| Form 3160-5 (June 2015) (Value 2015) DE | UNITED STATES PARTMENT OF THE INT UREAU OF LAND MANAGE | erior Carlsha | d Field Occupies | RM APPROVED B NO. 1004-0137 ss: January 31, 2018 | | | | |
|---|--|--|---|---|--|--|--|--|
| 1. Type of Well Gas Well Oth | ner | AUG | 8. Well Name and DIAMONDBA | 8. Well Name and No. DIAMONDBACK 24 FEDERAL COM 01 | | | | |
| 2. Name of Operator CHISHOLM ENERGY OPERA | Contact: JE ATING LLEGMail: JELROD@CH | NNIFER ELROPECE | 9. API Well No. 30-025-3562 | 9. API Well No. 30-025-35622-00-S1 | | | | |
| DIAMONDBACK 24 FEDERAL MIRU; PULL 2 7/8" TUBING | L COM 1-TEMPORARILY A | BANDON PROCEDURE | | | | | | |

Conditions of Approval for Temporary Abandonment of Wells

PROPOSED TEMPORARILY ABANDONDED WELLBORE DIAGRAM

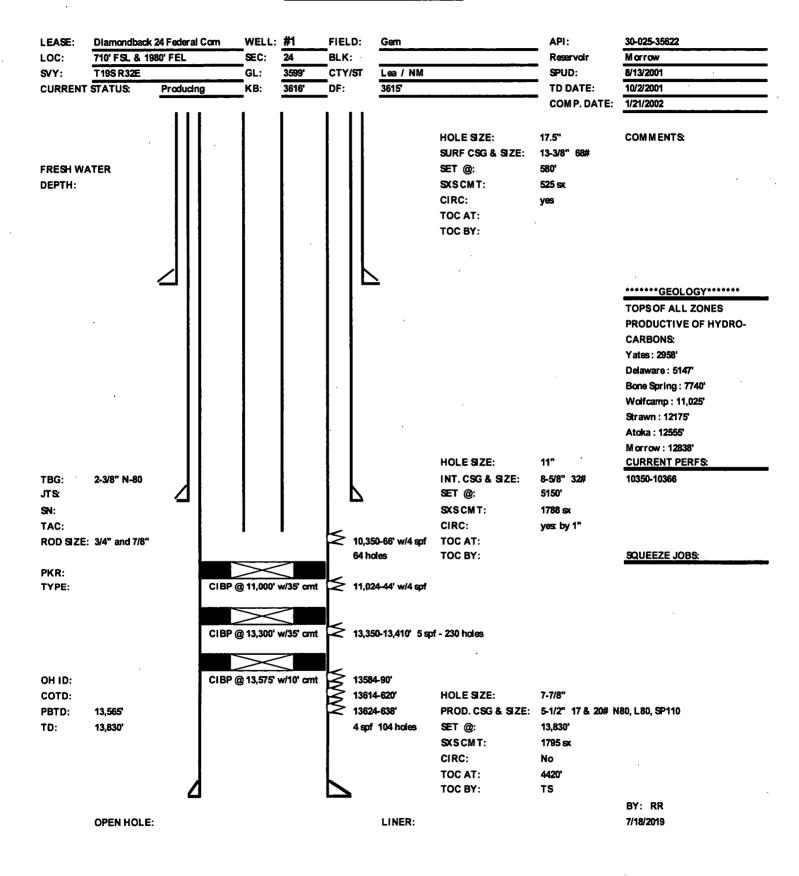
- A bridge plug (CIBP) must be installed 50 to 100 feet above any open perforations or open hole. The CIBP must be capped with either a minimum of 25 sacks of cement if placed with tubing or 35 feet of cement if placed with a bailer. The top of the cement must be verified by tagging.

- 2. The wellbore must be filled with corrosion inhibited fluid and pressure tested to 500 psi. The casing shall be capable of holding this pressure for at least 30 minutes. If the well does not pass the casing integrity test, then the operator shall, within 30 days, submit a procedure to either repair the casing or to plug and abandon the well.

- 4. All downhole production/injection equipment (tubing, rods, etc.) shall be removed from the casing if it is not isolated by a packer.
- 5. A bradenhead test must be conducted. If the test indicates a problem, a remedial plan and time frame for remediation shall be submitted within ninety (90) days of the test.

- 6. Submit a subsequent Sundry Notice (Form 3160-5) with the following information:
 - a. A well bore diagram with all perforations, CIBP's, and tops of cement on CIBP's.
